LOCAL REVIEW BODY

3 JANUARY 2018

CONTINUED PLANNING APPLICATION FOR REVIEW

**PROPOSED ERECTION OF RAISED DECKING AND BOUNDARY FENCE:
3 CARDROSS PLACE, GREENOCK (17/0186/IC)**

PROPOSED SITE PLAN - SCALE 1:200

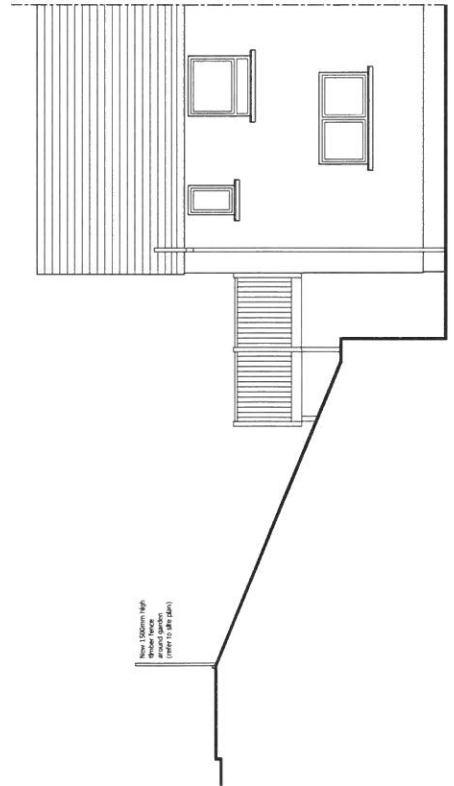
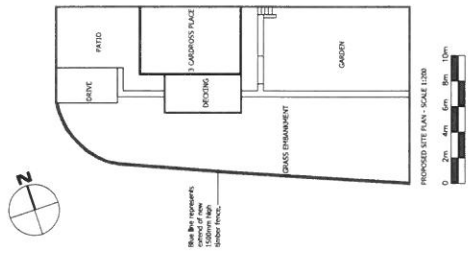
1.	The proposed new fence will replace an existing fence. The new fence line is on the boundary line of the property which is different from the existing fence. The visibility splay from Cardross Place to Clynder Road appears to be 2.4m by 30.0m with the new fenceline. This is acceptable as traffic is likely to be travelling slowly from the deadend on Clynder Road towards Cardross Place.
2.	The new fence also continues up to the driveway. The type of fence proposed provides no visibility of pedestrians on the footway or vehicles entering Cardross Place from Clynder Road. This is not acceptable. The applicant should lower the fence to 1.0m high from the driveway for a distance of approximately 4.0m.

Reference to these comments in the Report of Handling (Appendix 7) made by the case officer state that the advice is to lower the fence to 1.0 metre in height for a distance of 40metres from the driveway. The lowered height will only intensify the concerns regarding visibility of the proposals as well as overlooking/privacy implications. The distance of 40 metres is incorrect and should only be 4 metres. If the fence was only reduced over a distance of 4 metres, then the 1500mm high fence erected over the remainder of the side garden will still provide screening and assist with providing privacy from the street. Any pedestrians using the pavement on Clynder Road are unlikely to see the decking due to the height of the fence.
